**From:** Corey York  
**Sent:** Tuesday, May 29, 2012 4:33 PM  
**To:** Steve Ledoux  
**Cc:** Christine Joyce; 'Scott Hayes'  
**Subject:** RE: Proposed Street Parking Spaces on Spruce Street  
**Attachments:** PLAN - Spruce Strreet - On-Stret Parking - 1495PRK4.pdf

**CONCEPTUAL PARKING PLAN  
WEST SIDE OF SPRUCE STREET  
ACTON, MASSACHUSETTS**

DATE: MAY 16, 2012  
SCALE: 1 INCH = 20 FEET

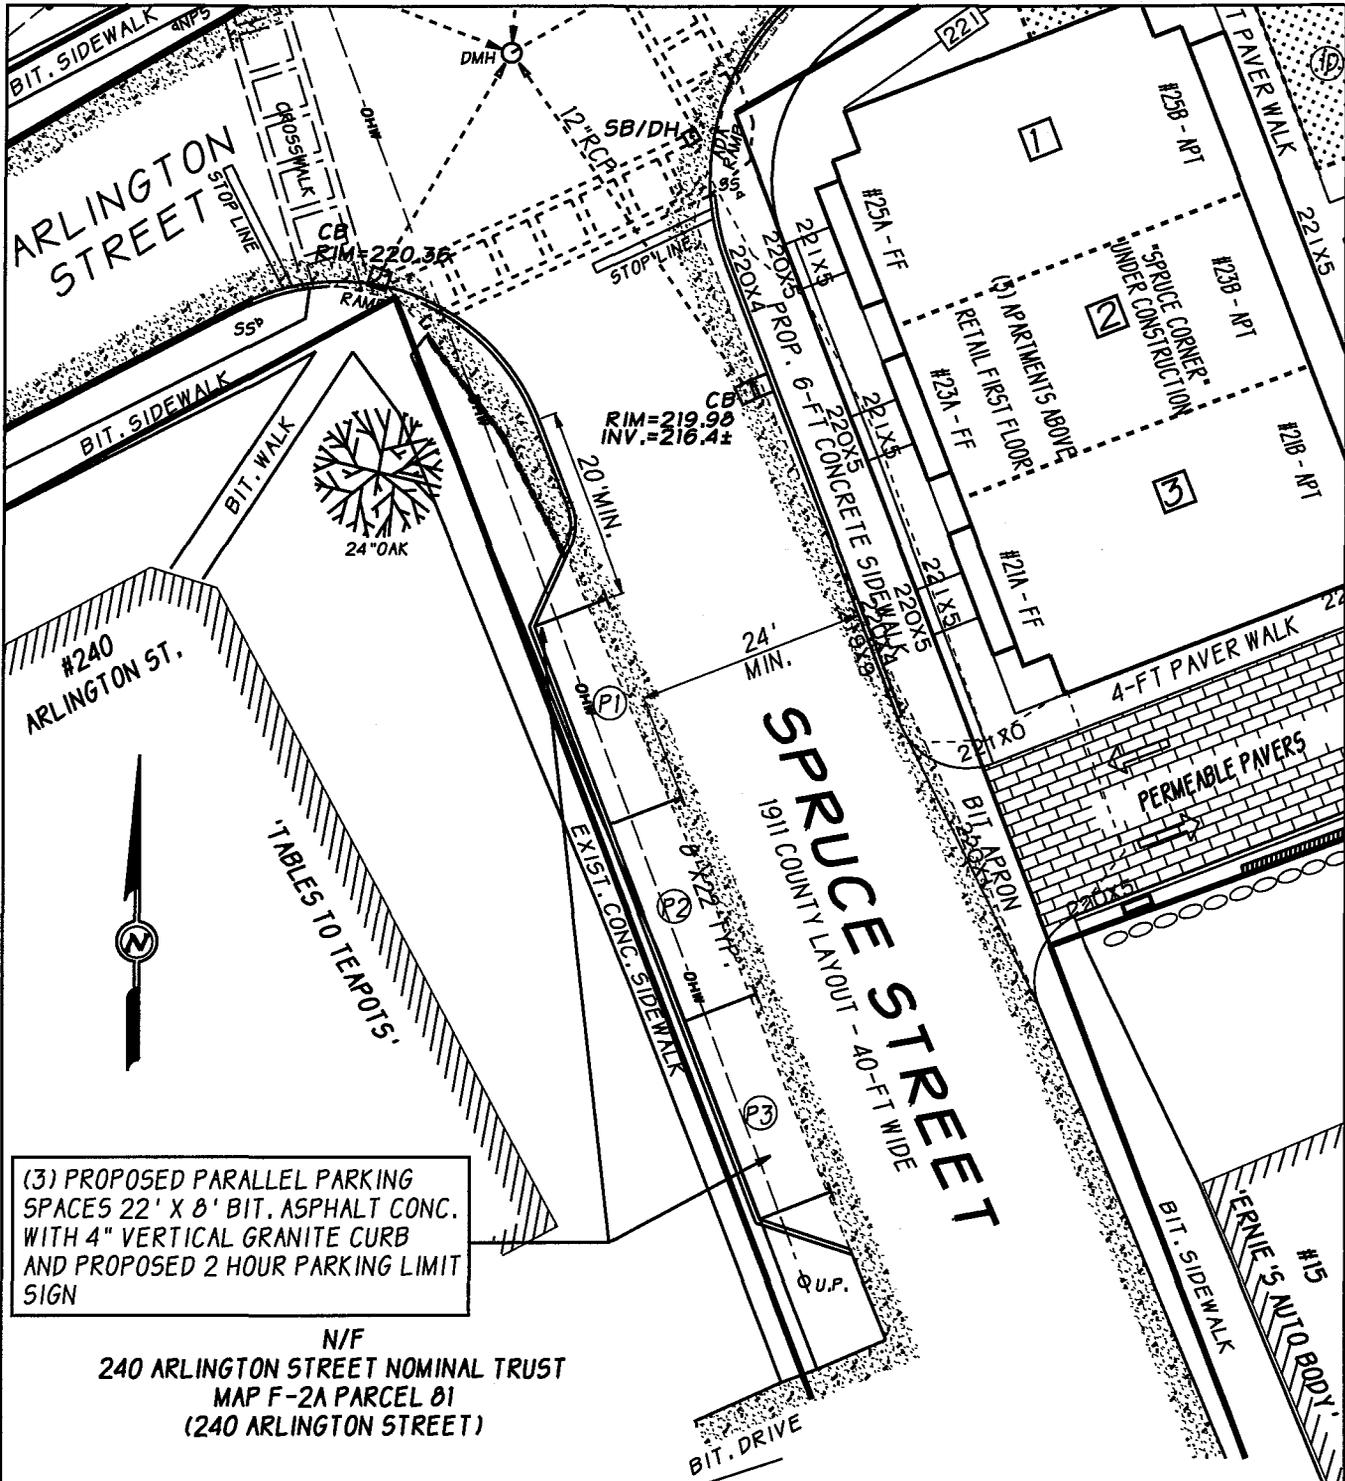
- The road pavement for Spruce Street will be no less than 24 feet wide.
- The three (3) proposed parking spaces will be 22 feet in length by 8 feet wide. This conforms to the parking standards established in the Zoning Bylaw.
- The proposed parking will have a 20 foot minimum offset from the paved intersection rounding at Arlington Street. This will conform to the TR&Os general parking prohibition at/near intersections.
- These spaces will remain open to the public
- The new parking spaces are shown to remain entirely within the Spruce Street layout

- Traffic Rules and Orders  
 I would agree that the Town should approve a time restriction for these spaces. If these parking spaces are approved, the Engineering Department will prepare an amendment to the existing Traffic Rules and Orders to remove the No Parking Restriction at this location and establish a 2-hour parking restriction to be consistent with the other streets in the area. The Town would then furnish and install the signage for the parking restriction.
- Existing Public Sidewalk  
 The relocated granite curbing should not impact the existing 5 foot wide concrete sidewalk along Spruce Street.
- Construction Requirements  
 The typical cross-section for the bituminous concrete should, at a minimum, comply with the standards set forth in the Subdivision Rules and Regulations for a street.

The granite curbing should be installed in the same manner as approved on their Spruce Corner development plans.

The applicant should be responsible for the pavement markings to delineate the three (3) parking spaces.

This is a village street location where in principle on-street parking makes a lot of sense and should be encouraged. The plan seems to work in general. While zoning does not apply within a street right-of-way, the proposed dimensions would comply with the zoning bylaw requirements. I defer to Engineering for any specific details.

I recommend that the parking spaces be approved to help mitigate some of the parking issues that are occurring in West Acton Center. It is also my understanding that the applicant is also working on modifications to the Spruce Corner plans to provide additional parking spaces on their own property.
